Engineering Change Notice																									
Doc Number: PD-P430HVN05.1 Product Type: 43 Model Name: P430HVN05.1 Issued Date: 2024/06/28	Requested by <table border="1"> <tr> <td>Signature</td><td><i>Jimmy Hsu</i></td><td><i>Travis Huang</i></td></tr> <tr> <td>Date</td><td>2024/06/28</td><td>2024/06/28</td></tr> <tr> <td>Name</td><td>Jimmy Hsu</td><td>Travis Huang</td></tr> <tr> <td>Title</td><td>PM</td><td>PM Manager</td></tr> </table>		Signature	<i>Jimmy Hsu</i>	<i>Travis Huang</i>	Date	2024/06/28	2024/06/28	Name	Jimmy Hsu	Travis Huang	Title	PM	PM Manager												
Signature	<i>Jimmy Hsu</i>	<i>Travis Huang</i>																								
Date	2024/06/28	2024/06/28																								
Name	Jimmy Hsu	Travis Huang																								
Title	PM	PM Manager

1. Purpose P430HVN05.1 LED driver board output current reduced from 80mA to 67mA; Power consumption reduced from 134.9W to 110W

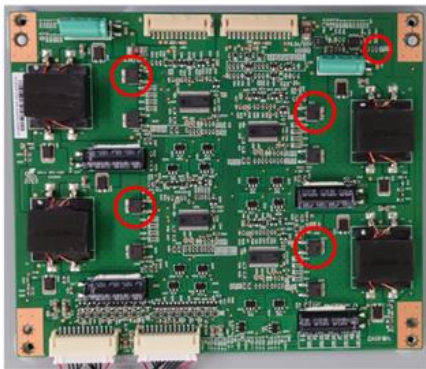
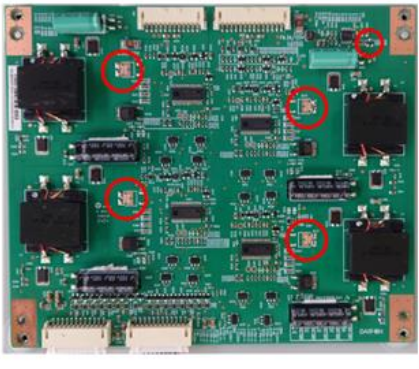
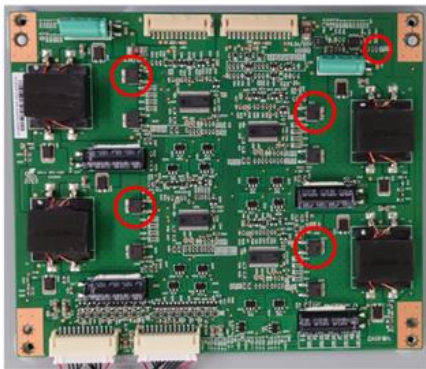
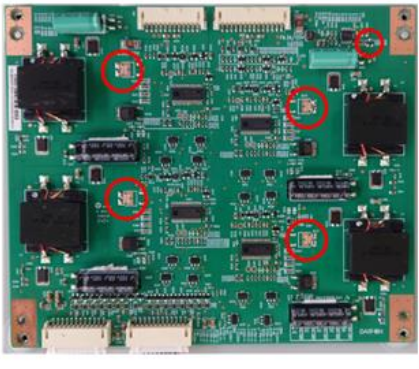
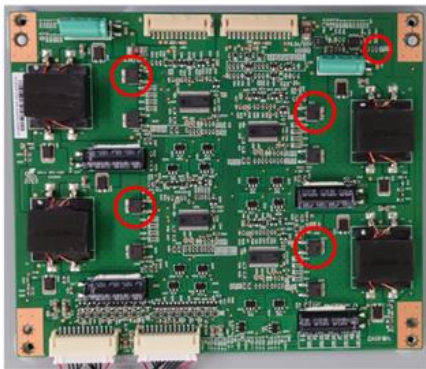
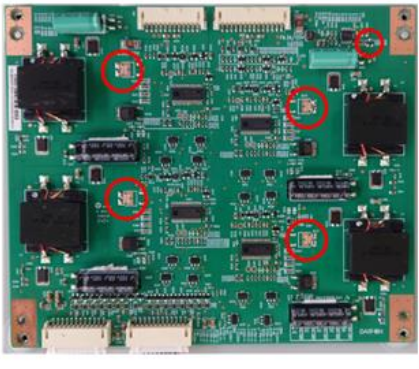
2. Changes LED driver board output current reduced from 80mA to 67mA																										
3. Desired Implementation Method & Date 2024/7/13; running change

3. Attachment																										
<table border="1"> <tr> <td colspan="2">P430HVN05.1 before EC²</td> <td colspan="2">P430HVN05.1 After EC²</td> </tr> <tr> <td colspan="2"></td> <td colspan="2"></td> </tr> <tr> <td>Model Name</td> <td>P430HVN05.1 (before EC)</td> <td>P430HVN05.1 (after EC)</td> <td></td> </tr> <tr> <td>Output Current</td> <td>80mA</td> <td>67mA</td> <td></td> </tr> <tr> <td>Output MOS</td> <td>2pcs (For Thermal) * 4_DCDC</td> <td>1pcs * 4_DCDC</td> <td></td> </tr> <tr> <td>Q106</td> <td>NA</td> <td>Add (reduce power consumption during standby mode)</td> <td></td> </tr> </table>			P430HVN05.1 before EC ²		P430HVN05.1 After EC ²						Model Name	P430HVN05.1 (before EC)	P430HVN05.1 (after EC)		Output Current	80mA	67mA		Output MOS	2pcs (For Thermal) * 4_DCDC	1pcs * 4_DCDC		Q106	NA	Add (reduce power consumption during standby mode)	
P430HVN05.1 before EC ²		P430HVN05.1 After EC ²

V100(Before EC)	V101(After EC)
DB Output Current	80mA	67mA
Power Consumption	134.9W	110W
Brightness	1500nits	1500nits
